# Per-Lane CTLE

Jeffery J. Maki

## Comment #39 – Juniper

## Comment #136 – Cisco

# CFP8 Form Factor

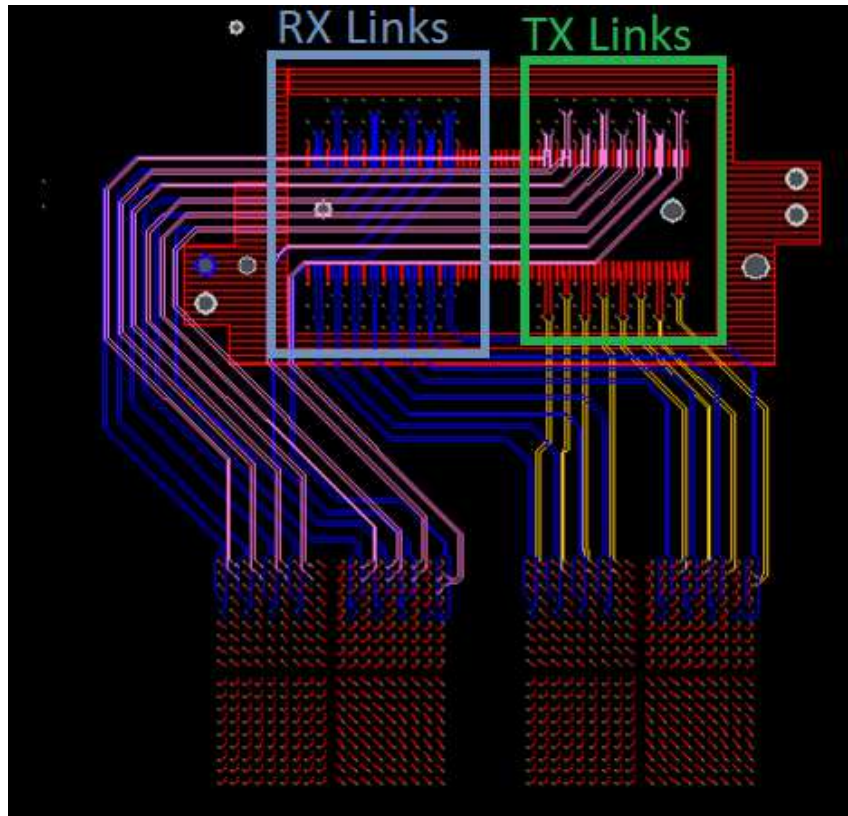
PCB routing cannot easily be made such that a per-module CTLE value is sufficient for CDAUI-16

- Paths would become excessively serpentine to match path lengths, which takes up board space and increases path lengths
